**ZAP SITE PLAN REVIEW SHEET
ENVIRONMENTAL VARIANCE REQUEST ONLY**

CASE: SP-2012-0350C **ZAP COMMISSION DATE:** April 2, 2013

PROJECT NAME: Dessau Retail Center

Dessau Retail Center
SP-2012-0350C
Site CEF's

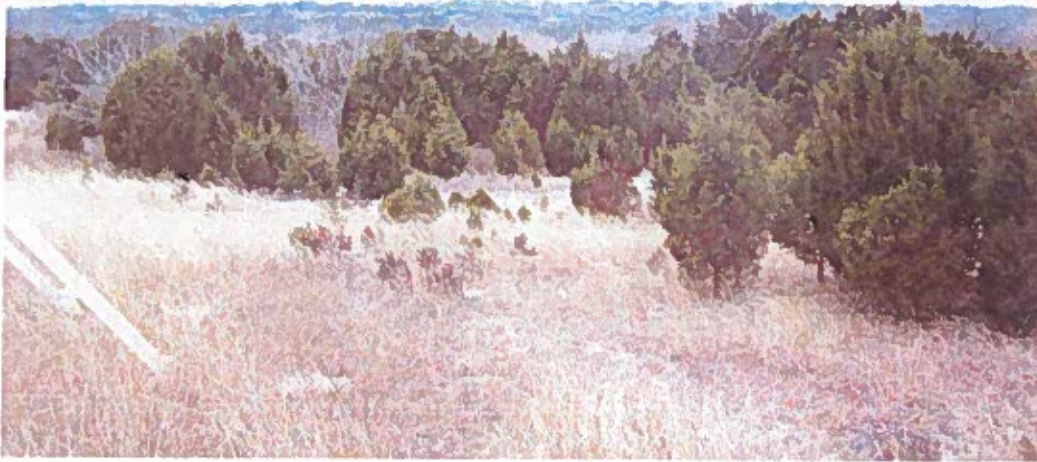
Yes. Normally, the reductions proposed to CEF's #1 and #3 are small enough that they could have been granted administratively, but since the reduction requested on CEF #4 could not be granted administratively, they are all being forwarded for Board and Commission review and approval. This variance will not increase harmful environmental consequences. The proposed layout provides CEF protection while maintaining flows from the two seeps.
